Access Compliance Report

Public Rights-of-Way

(Curb Ramps)

Intersection ID: 45182	Main Street: MAPLEHURST_DR	Cross Street: SOCIETY_ST	Location: NE
ADA ID: D2DB8E38F9F1	Ramp Type: Perp	Initial Pass/Fail: Fail	Overall Compliance: No
Severity Score: 8.75			
Codes/Mitigation Info/Possible Solution		Field Measurements/Component Compliance

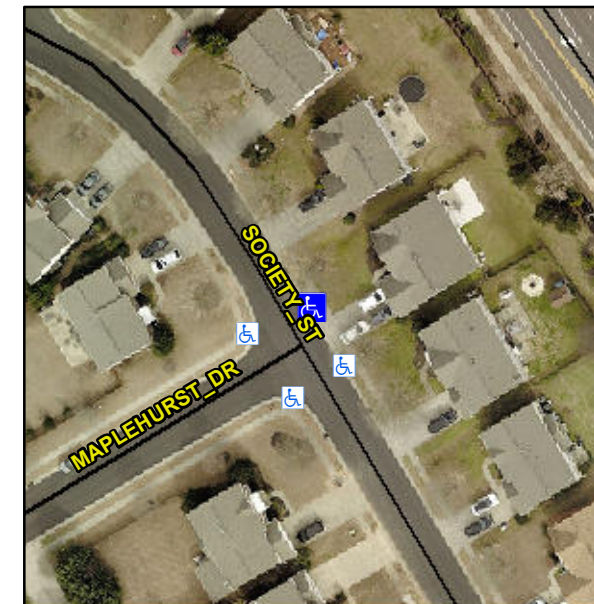
Not Found, R304.5.1

Compliance	Description	Data	Compliance	Description	Data
N/A	Ramp Length (in)	95.0	Yes	Ramp Slope (%)	5.9
No	Ramp Width (in)	37.5	Yes	Ramp XSlope (%)	1.8
N/A	Flare Type LT	N/A	N/A	Flare Type RT	N/A
N/A	Flare Slope LT (%)	N/A	N/A	Flare Slope RT (%)	N/A
N/A	Flare Traversable LT?	N/A	N/A	Flare Traversable RT?	N/A
N/A	Landing Length (in)	N/A	N/A	DWS Provided?	N/A
N/A	Landing Width (in)	N/A	N/A	DWS Contrast?	N/A
N/A	Landing Slope (%)	N/A	N/A	DWS Length (in)	N/A
N/A	Landing X Slope (%)	N/A	N/A	DWS Full Width?	N/A
N/A	Landing Curb? (Y/N)	N/A	N/A	DWS Offset (in)	N/A
N/A	Shared Landing?	N/A			
N/A	Gutter Ponding?	N/A	N/A	Gutter Slope (%)	N/A
N/A	Gutter Lip Ht (in)	N/A	N/A	Gutter X Slope (%)	N/A
N/A	Painted X Walk1?	No	N/A	Painted X Walk2?	N/A
	X Walk 1 Direction	To SW		X Walk 2 Direction	N/A
N/A	X Walk 1 Width (in)	N/A	N/A	X Walk 2 Width (in)	N/A
	X Walk 1 Slope (%)	3.1		X Walk 2 Slope (%)	N/A
	X Walk 1 X Slope (%)	1.7		X Walk 2 X Slope (%)	N/A

N/A	Ramp inside XWalk1?	N/A	N/A	Ramp inside XWalk2?	N/A
	Road Slope (%)	N/A	N/A	Clear Space?	N/A
	Road X Slope (%)	N/A	N/A	Clear Space to XWalk (in)	N/A
N/A	Any Obstructions?	N/A	N/A	Storm Grate/Utility Hazard?	N/A
	Obstruction Type			Storm Grate/Utility Type	
		N/A			N/A
			Yes	Surface Condition? (G/P)	Good

Possible Solutions:

Remove & Replace Entire Ramp.
